Westfield Penrith DA Access Report

This Access Australia (AA) Report accompanies a DA for alterations and additions to Westfield Penrith NSW and relates to instructions and documents received to date from Scentre Group.

Basement 'accessible' parking

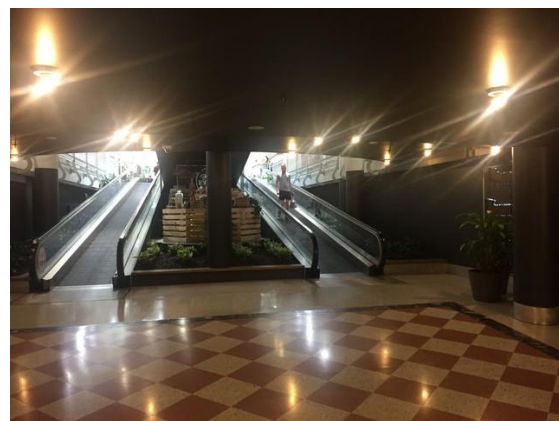
Basement car park provides 13 non-complying 'accessible' car spaces 4000± wide with 2800± ceiling height. There are no adjacent shared spaces.

The accessible car spaces have generally level access to 1700± wide automatic entry doors, with travelators and non-complying ramps to upper levels. Travelators are not part of an accessible path of travel and lift access is not provided.

Non-complying car parking ramps

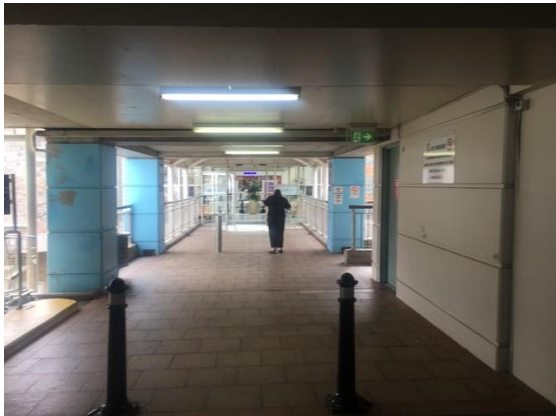
Access to Level 2 is provided by travelators, escalators and non-complying ramps within the car parking structure.

Level 1 proposed works

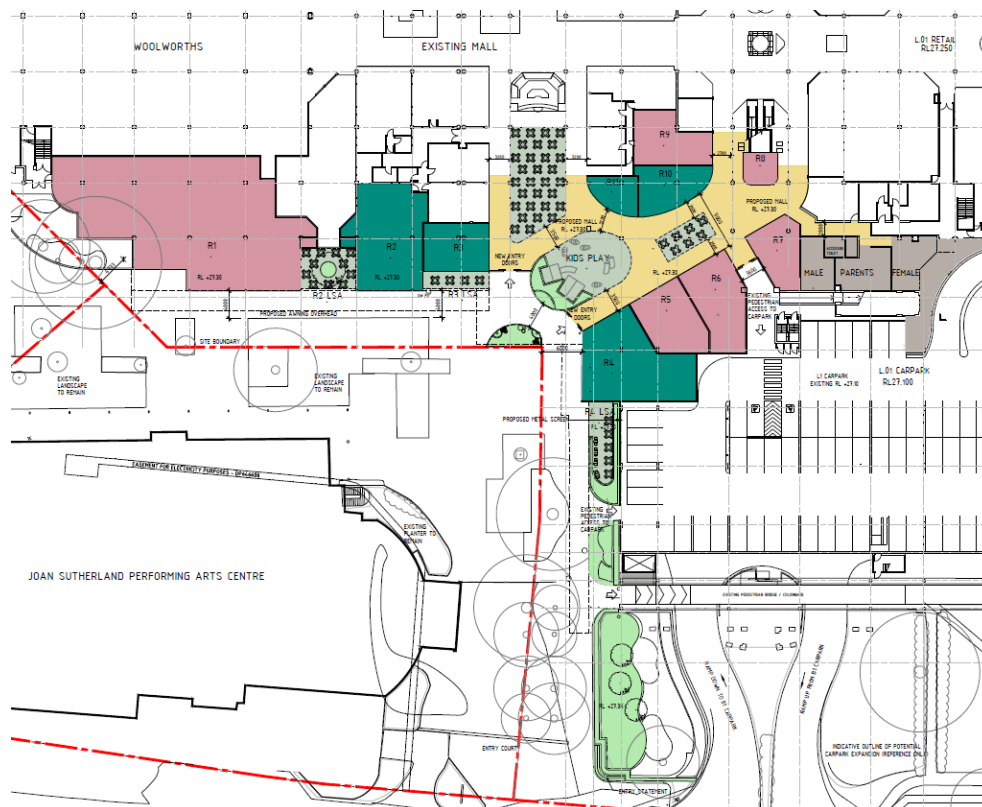
Existing amenities to be decommissioned, existing entry to be demolished and existing shop fronts opposite JSPAC to be removed. Part of existing L01 carpark to be demolished.

New entry and mall areas, new food, retail, kids play, seating and mall areas on south side of existing mall, entry via JSPAC public areas. New male, female, parent toilets – accessible and PAD toilets to be provided.

Provide minimum 20% indoor and outdoor seating with complying backs and armrests.

The proposed DA involves modifications to 2 levels of the existing High Street carpark. Two new accessible car spaces provided at L.01 adjacent to mall entry with shared space. Parking to comply with NCC / BCA required accessible parking as attached extracts. Refer Colston Budd 2017 reports.

Ramp access provided to parking upper levels – ramp compliance to be reviewed. Two new complying car spaces at Mezzanine level with generally accessible path of travel (POT) to mall.

Level 1 / Ground & Mezzanine	Access criteria APS, BCA & Standards	Compliance
Paths of travel (POT) and entries	Provide accessible POTs between main entrance, lift lobby and carparking, and minimum 850 doors with complying nibs and circulation, and complying decals to glazed entry doors	Complies subject to detailed design
	Provide complying stairs, ramps and tactile indicators	Subject to detailed design
	Comply with Penrith DCP 2014 including minimum 2.5m wide footpaths	Complies
	Provide complying lift or ramp access to retail areas	Pending

Level 1 / Ground & Mezzanine	Access criteria APS, BCA & Standards	Compliance
Accessible parking	Provide minimum 2.4m wide accessible parking spaces with adjacent 2.4m wide shared spaces, complying with the BCA and AS2890.6-2009	Complies subject to detailed design
	Provide maximum 1:40 cross fall, minimum 2.2m driveway height, minimum 2.5m parking space height, and install ISA (International Symbol of Access) ground and vertical signage and accessible POT	Subject to detailed design
Passenger lift	Provide complying circulation space, minimum 900 wide door and minimum 1100 x 1400 car size, Braille & tactile controls 900 to 1200 high, handrails adjacent to controls and audio announcements	Subject to detailed design
Fixtures, fittings and equipment (FF&E)	Provide an equitable range of accessible FF&E including minimum 1m wide section of accessible counters	Subject to detailed design
Amenities	Install NCC / BCA complying accessible facilities where gender specific amenities are provided	Subject to detailed design

Public domain	Provide accessible paths of travel	Complies
	Install minimum 20% of seating to comply with AS1428.2 including seat backs and armrests	Subject to detailed design
Signage	Install consistent and accessible identifying signage with minimum 30% luminance contrast between signage and background	Subject to detailed design

Level 3 proposed works

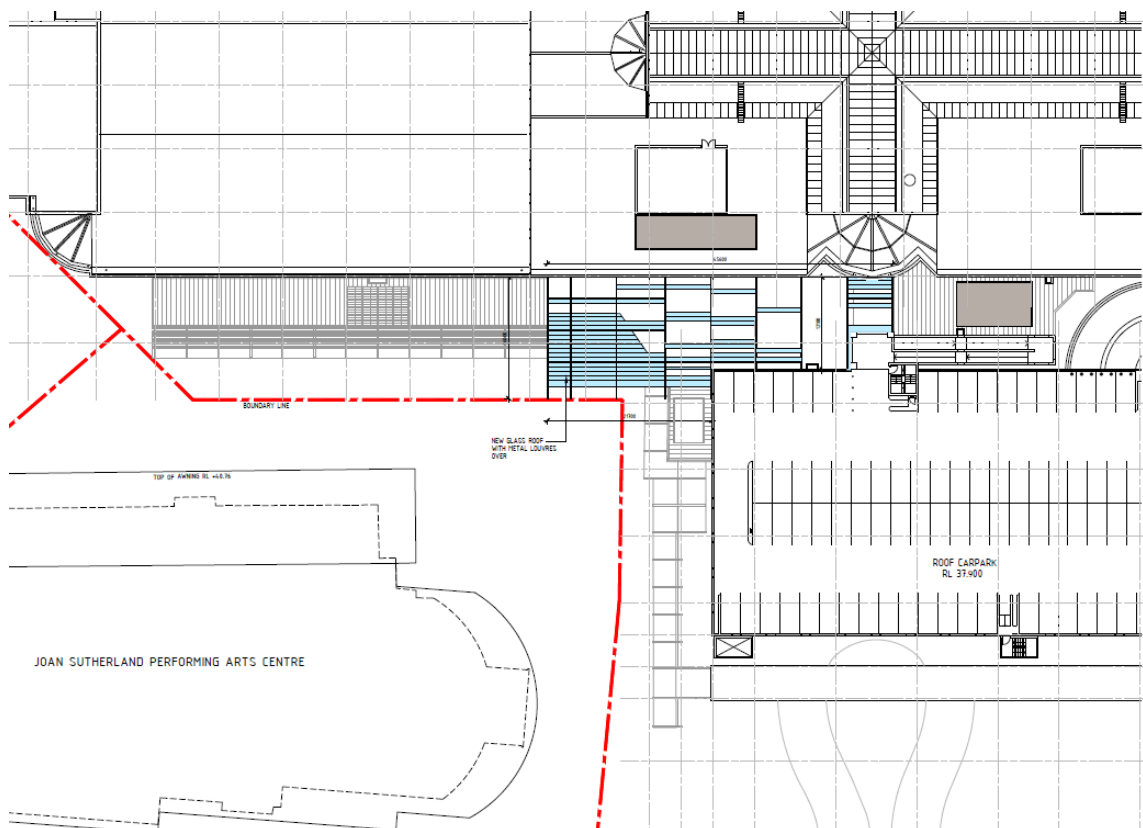
Roof car park with no accessible car spaces.

Level 3	Access criteria APS, BCA & Standards	Compliance
Paths of travel (POT) entries, passenger lifts, amenities and FF&E	Comply with Level 1 / Ground requirements	Complies subject to detailed design
Accessible parking, stairs signage	Comply with Level 1 / Ground requirements	Subject to detailed design
